Revised Addendum #2 to 2023 Subsequent Mitigated Negative Declaration

**Water System Reconstruction Project-
Water Supply and Storage Improvements
SCH No. 2020080439**

Mendocino Unified School District

5 May 2026, Revised 14 July 2026

Existing & Proposed Aquatic Resources

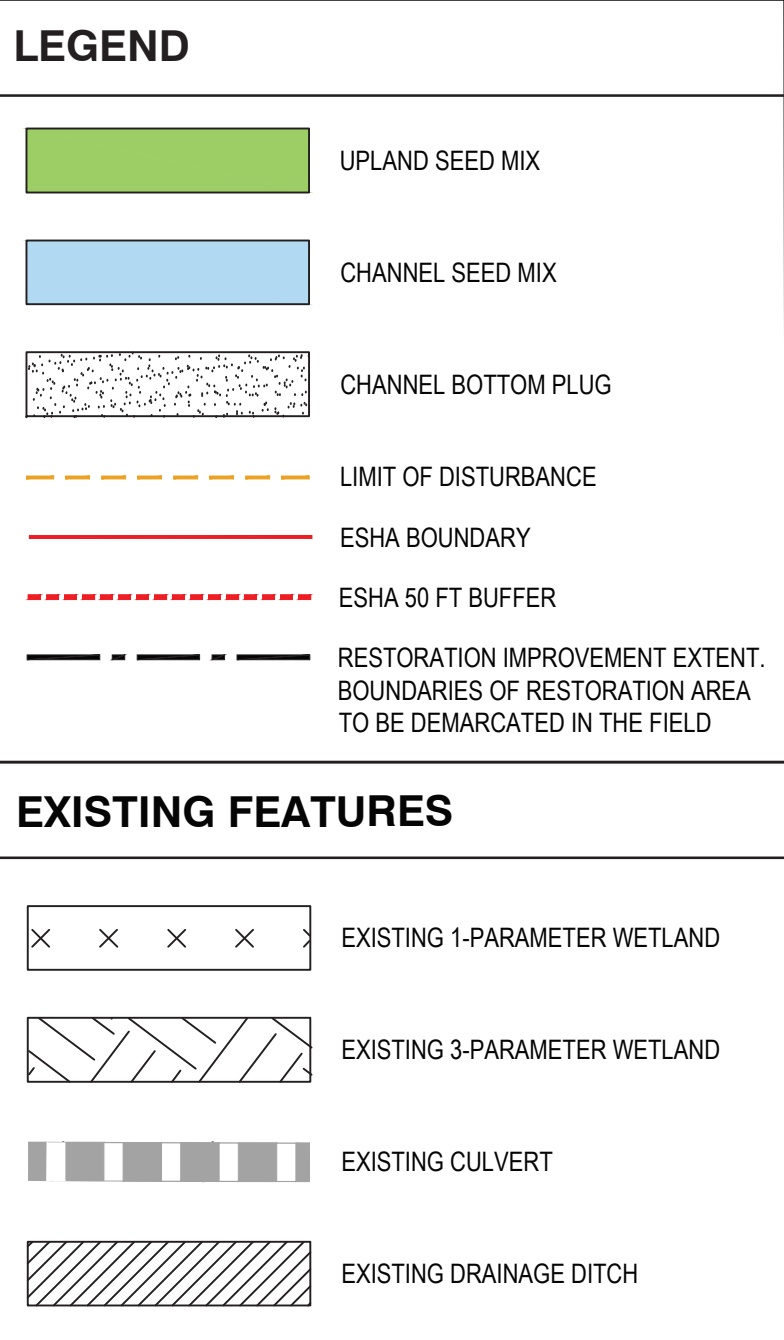
The project site includes two unnamed watercourses, referred to as WC1 and WC2 (see Figure 2 Delineated Aquatic Resources). WC1 and WC2 merge on site and eventually drain to Slaughterhouse Gulch off site. WC2 originates from a headwater swale and forms a narrow channel with generally perennial flow that increases during rain events. Downstream of the swale, WC2 has been culverted in multiple locations and re-aligned in a straight, engineered configuration, including a combination of open channel segments, buried pipes, and culverts. WC2 would be rerouted and restored (see Figure 3 Existing and Proposed Aquatic Resources) to improve channel function and continuity. Approximately 145 linear feet of new open channel would be constructed along a northwest alignment, as shown on the project plans (Attachment 1, Restoration Plan Set). There are three existing culverts along WC2. The reroute would begin immediately upstream of the second downstream culvert and would reconnect with WC1 just downstream of the third downstream culvert.

Construction activities associated with the reroute and restoration would include excavation and grading to form the new channel alignment. Temporary disturbance would occur within the existing channel at the upstream and downstream connection points. The channel would be constructed from downstream, and progress to the upstream connection point. A temporary silt fence would be installed at the upstream end of the restored channel and around the upstream culvert entrance to filter any sediment generated during construction. Following completion of the rerouted channel, the abandoned culvert would be sealed and decommissioned, and the existing drainage ditch adjacent to the Maintenance Building would be filled and revegetated, consistent with the Restoration Plan.

Attachment 1: Restoration Plan Set

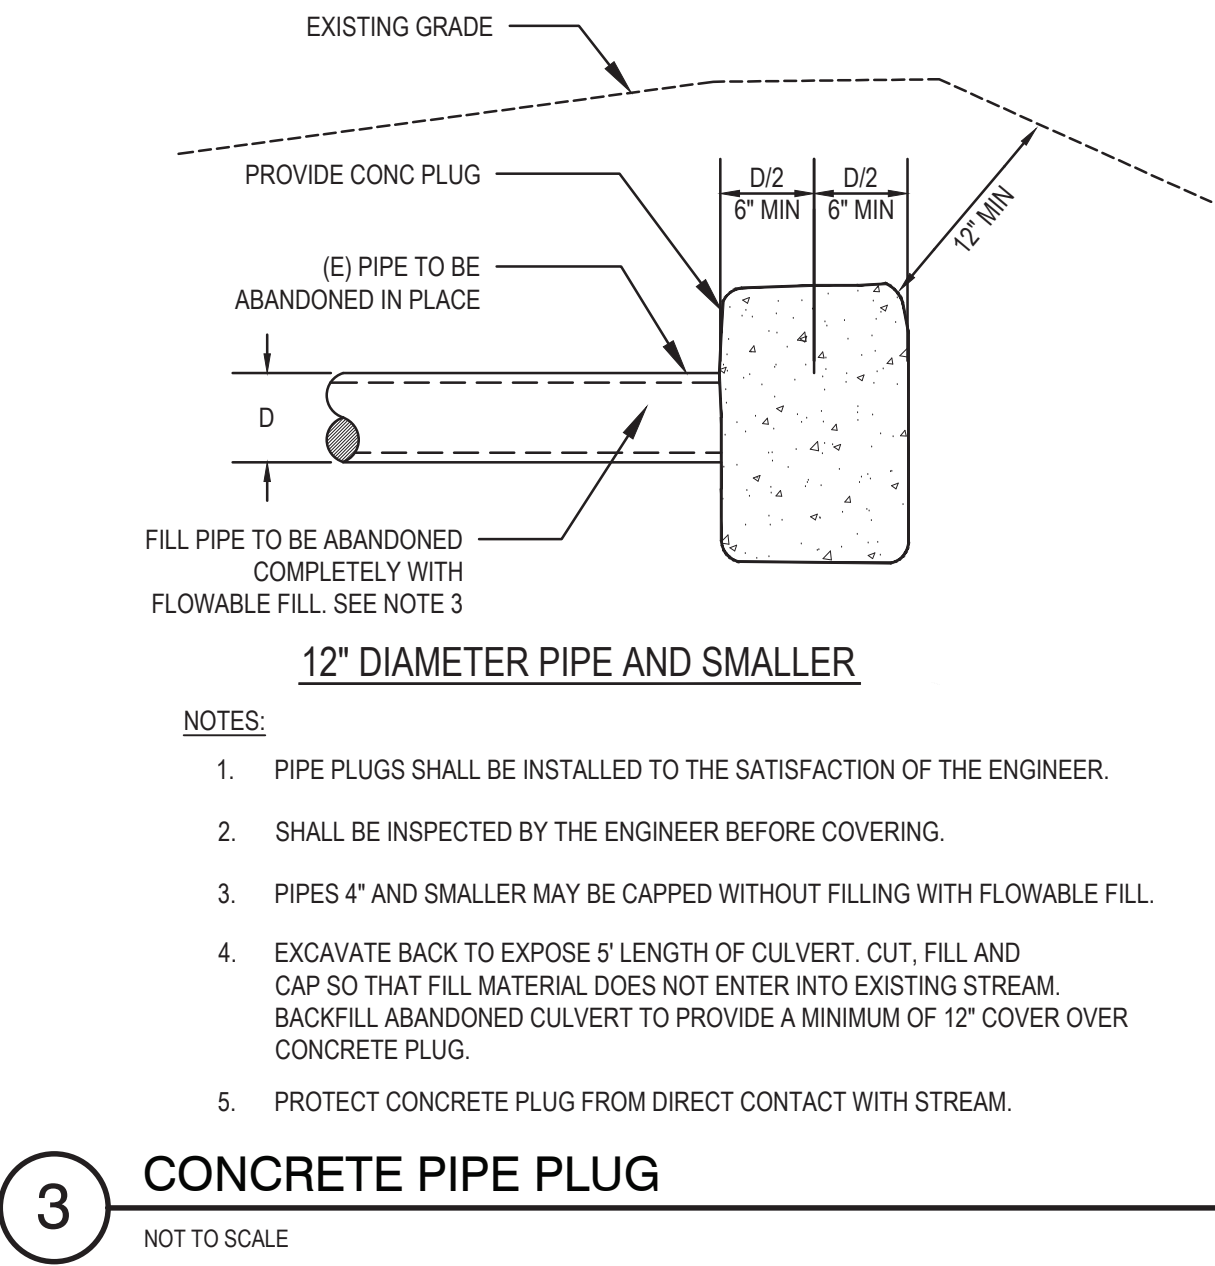
- THE CHANNEL WAS DESIGNED TO PREVENT SCOUR DURING PEAK FLOW EVENTS.
- PEAK FLOWS WERE DETERMINED BASED ON THE MAX. FLOW CAPACITY OF THE UPSTREAM CULVERT (6" DIA.), WHICH WAS DETERMINED TO BE 2 CFS.
- THE RESULTING VELOCITY (2.8 FT/SEC) AND SHEAR STRESS (1.1 LB/FT²) WERE USED TO DETERMINE THE APPROPRIATE CHANNEL LINING.
- THE RESULTING DEPTH OF FLOW (<6") RESULTS IN SUFFICIENT FREEBOARD TO PREVENT OVERTOPPING.

1	FILL, PLUG, AND COVER EXISTING CULVERT TO ABANDON IN PLACE PER DETAIL 3 ON THIS DRAWING
2	BACKFILL EXISTING CHANNEL ADJACENT TO BUILDING FOUNDATION
3	LOW SYMBOLIC FENCING (LOGS)
